Memorandum to the City of Markham Committee of Adjustment

File: A/068/22
Address: 31 Christman Court – Markham, ON
Applicant: Allan Seychuk
Agent: David Small Designs (Julie Odanski)
Hearing Date: August 10, 2022

The following comments are provided on behalf of the East District team. The applicant is requesting relief from the following “Residential One – (R1)” and “Open Space – (O)” zone requirements under By-law 1229, as amended, as they relate to a proposed two-storey detached dwelling. The variances requested are to permit:

APPENDIX “B”

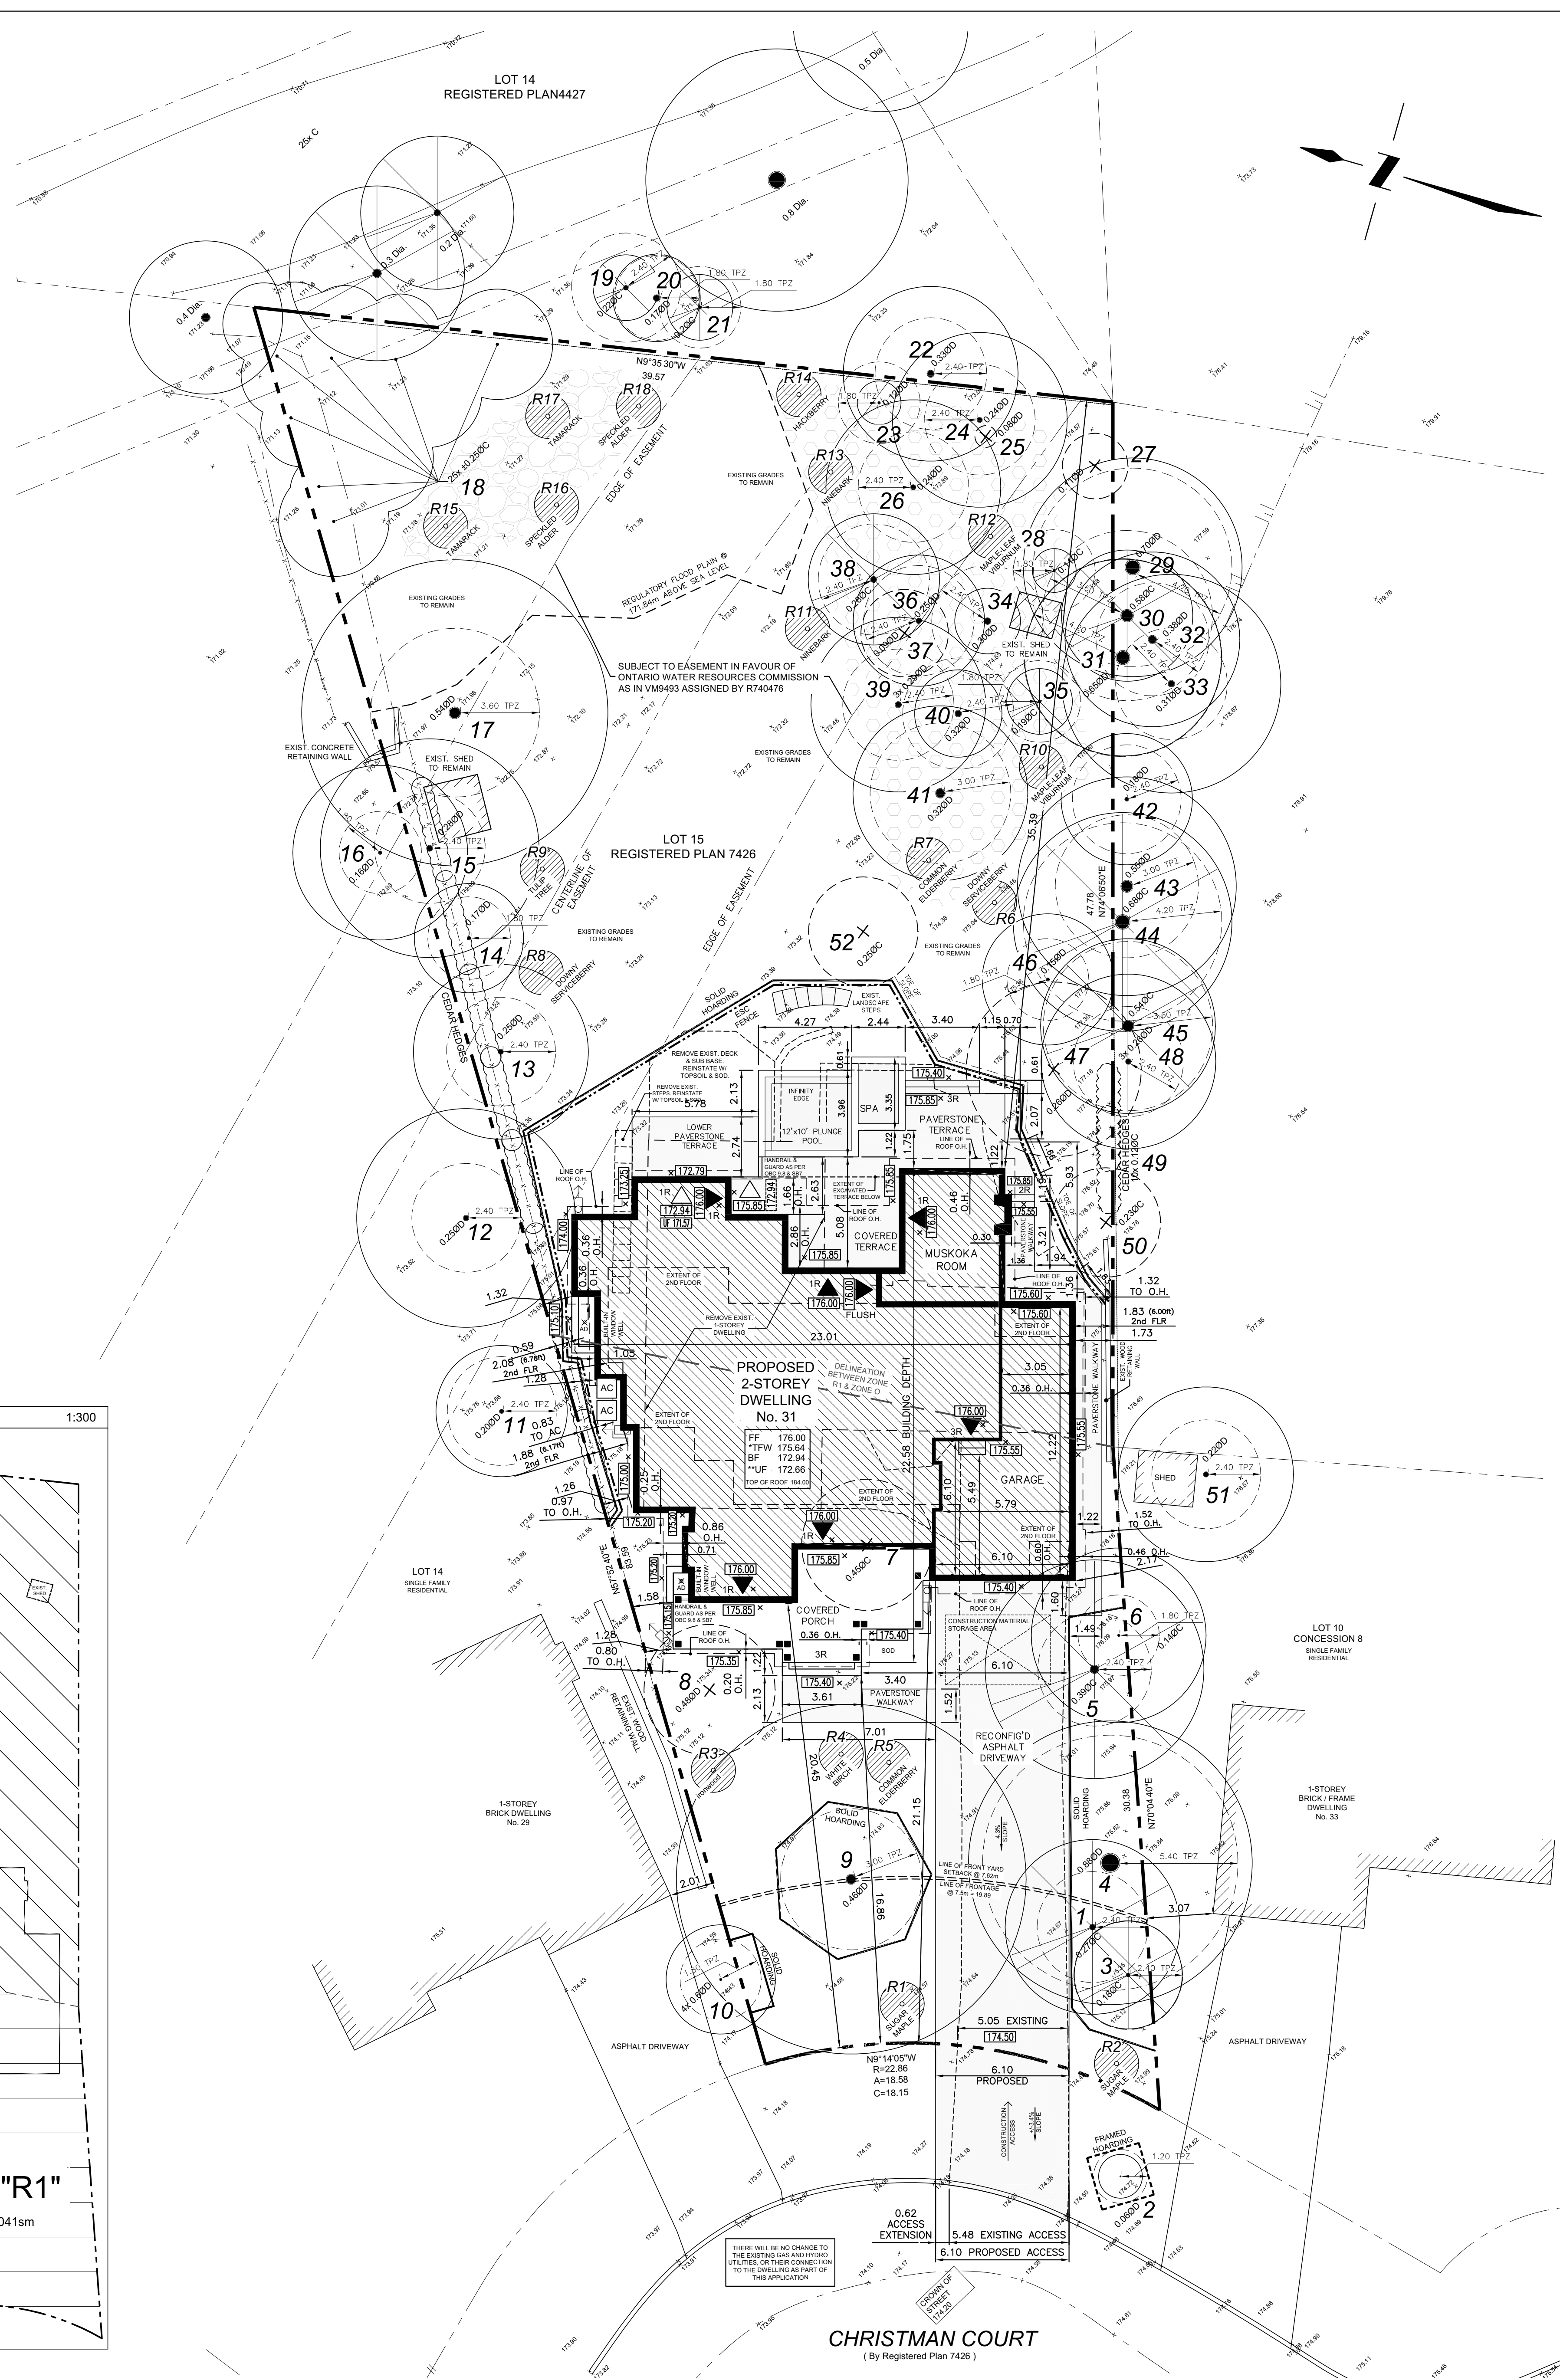
The applicant has worked with the TRCA to determine an appropriate limit of development delineated by the sediment fence shown on the Site Plan (Appendix "B"). Accordingly, the TRCA has no objections to the minor variance application, provided that the applicant remits a fee for the review of this minor variance application, and that a conservation permit be obtained.

6. That the applicant obtain a Conservation Permit from the TRCA, and satisfy the requirements of the TRCA as indicated in their e-mail dated June 14, 2022, and that the Secretary-Treasurer receive written confirmation that this condition has been fulfilled to the satisfaction of the TRCA.
